RVL50-D-02

rev:8-11-2022

Build-To Sheet

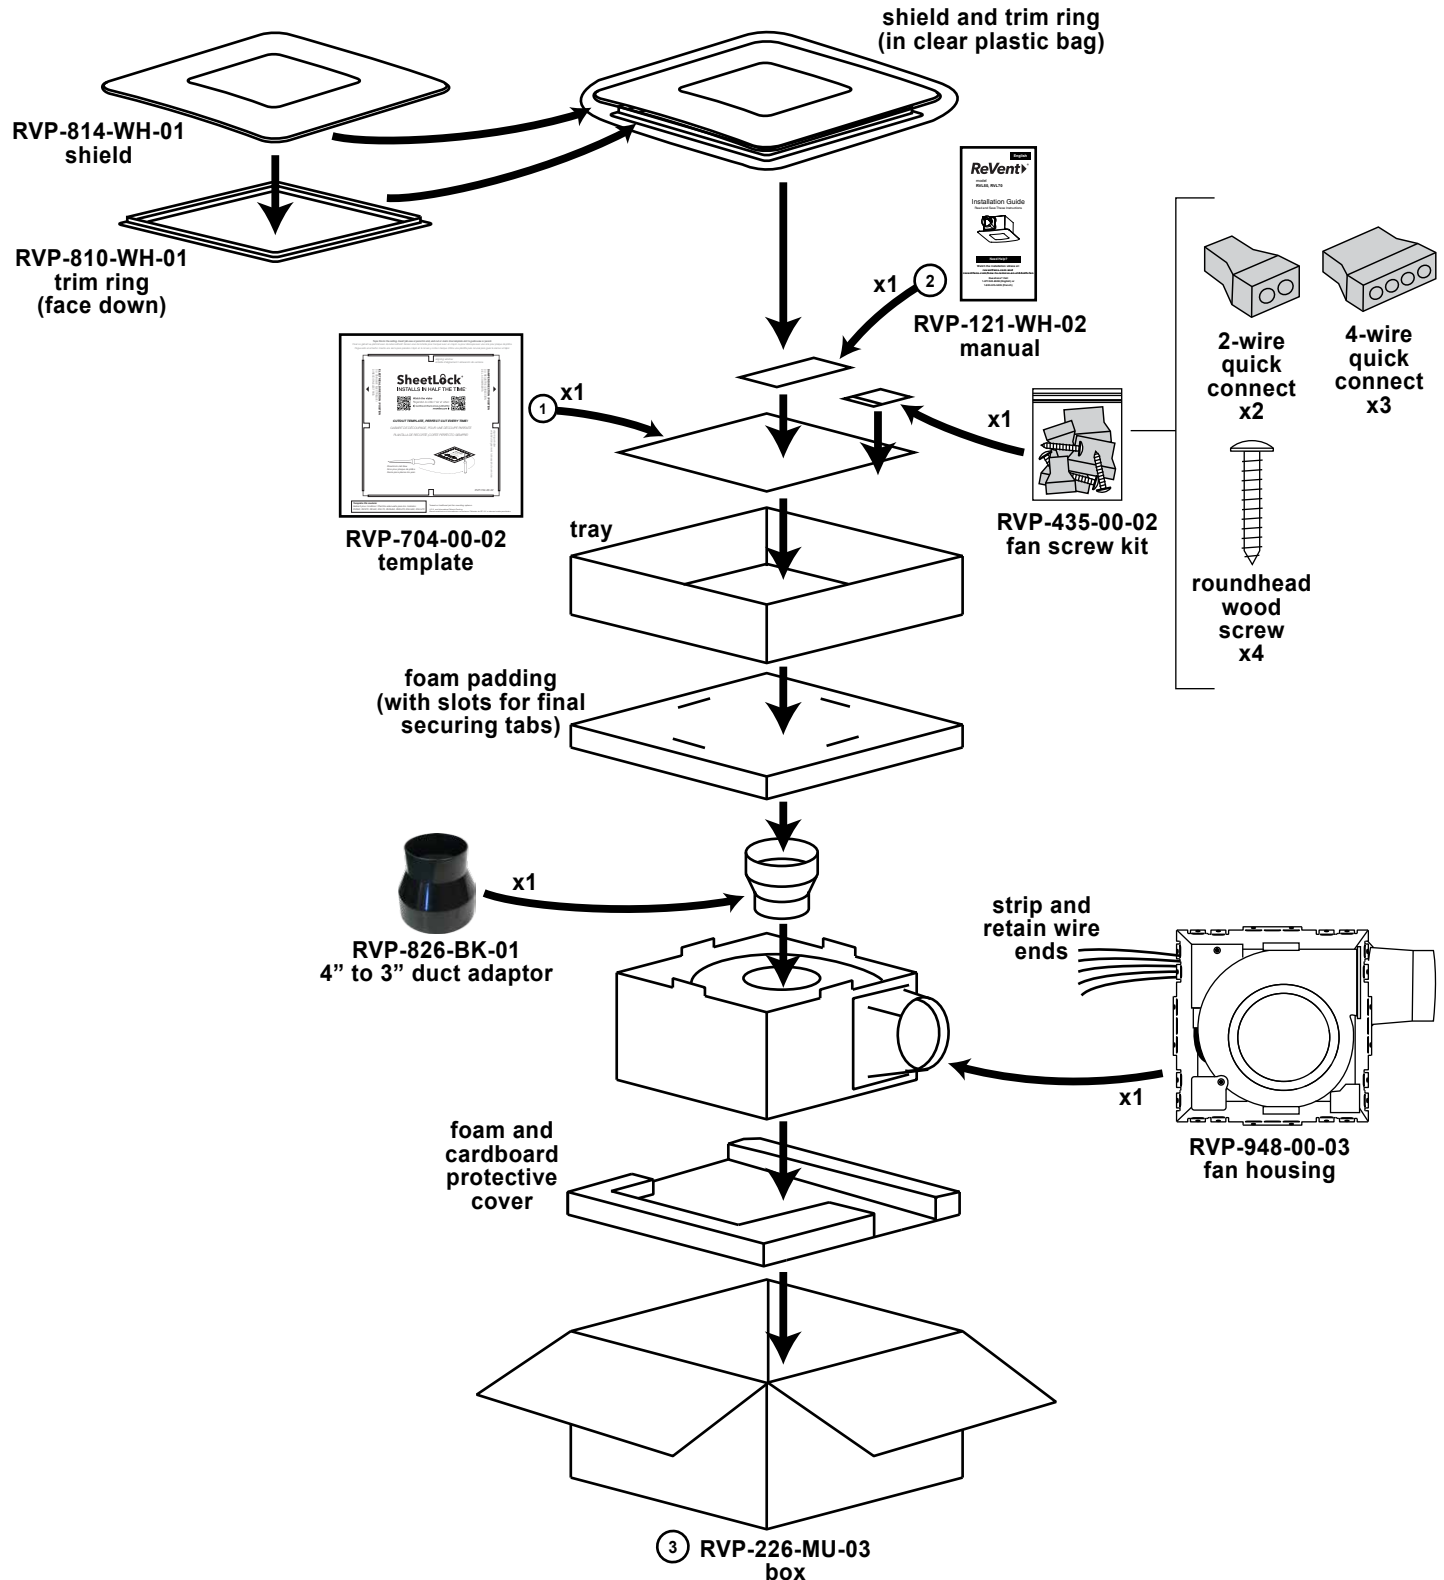
8/11/2022	RVP-814-WH-01	Changed shield part # from RVP-811-WH-01 to RVP-814-WH-01 to match correct shield for this model fan (this wasn't done before because of a mistake) (page 1)

Label Placement (bottom of motor)

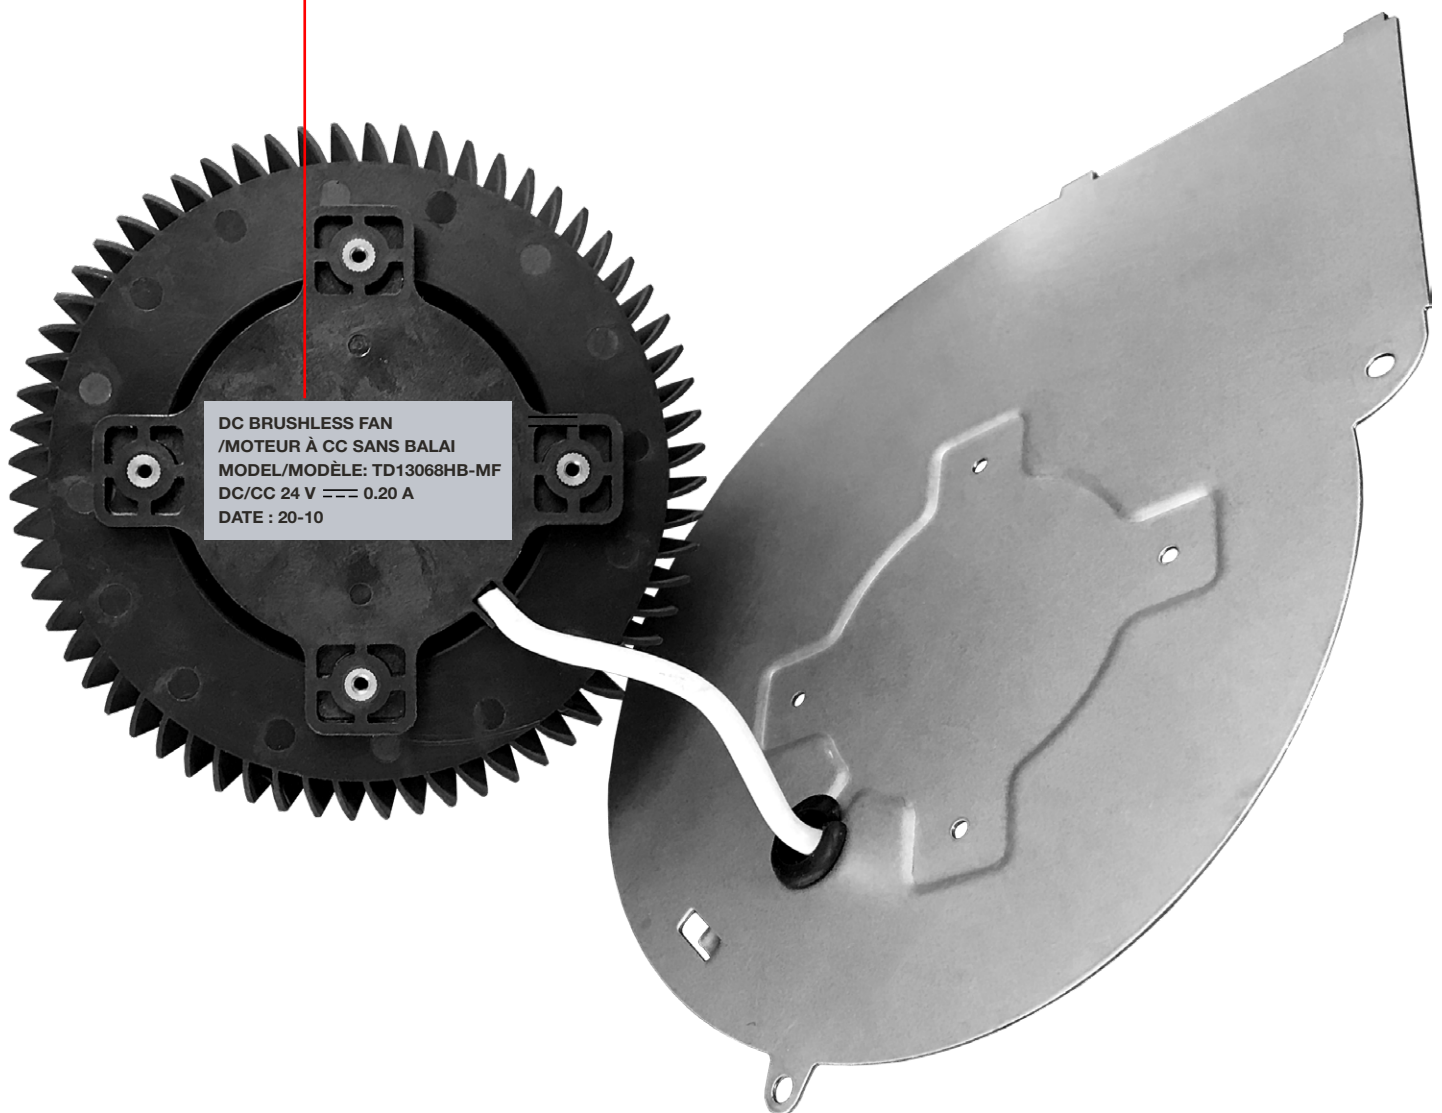
RVP-226-MU-01	Updated box (corrected performance specs [Sone, W, CFM] to match HVI report and removed HVI *) (page 1-2)
	RVP-948-00-01	Updated fan laser printing (corrected performance specs [Sone, W, CFM] to match HVI/UL reports) (page 4)
10/27/2021	RVP-121-WH-01	Updated manual (R40 changed to R-50, corrected performance specs [Sone, W, CFM] to match HVI report and removed HVI *, corrected FAQ) (page 1)
	RVP-226-MU-01	Updated box (R40 changed to R-50, added patent claim) (page 1-2)
11/1/2021	RVP-121-WH-02	Manual part # updated from -01 to -02 (page 1)
	RVP-435-00-02	Screw kit part # updated from -01 to -02 (page 1)
	RVP-226-MU-02	Updated box (added patent claim, added box part# to bottom of box) (page 1-2)
	RVP-948-00-02	Updated fan laser printing (changed "PRC" to "China") (page 4)
11/24/2021	RVP-226-MU-03	Corrected box (changed "x" to "to" on cm Duct dimensions on side of box) (page 1-2)
12/1/2021	RVP-948-00-03	Updated fan motor label (added French to make it generic with DC models) (page 5)
